Access Compliance Report Public Rights-of-Way (Curb Ramps)

Main Street: CELESTINE_CIR Cross Street: CANDLEWIND_CT Location: NW

ADA ID: RPAT211029121026 Ramp Type: Type 4 - Parallel Initial Pass/Fail: Fail Overall Compliance: No Severity Score: 2

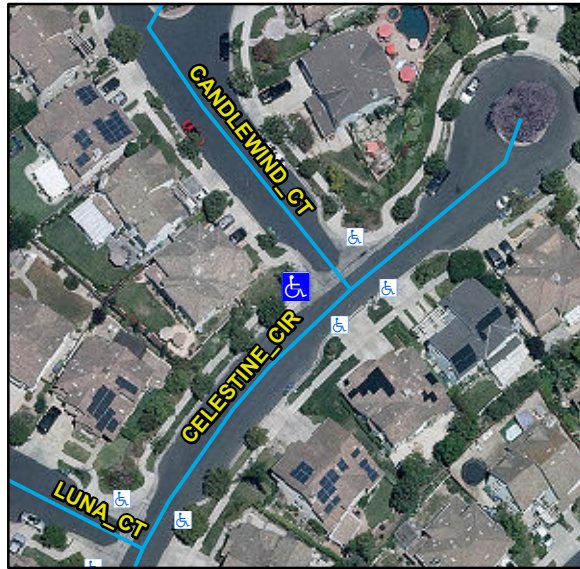
R304.5.3, STD 1115

Remove & Replace Curb Ramp With Two New Directional Ramps or Equivalent.
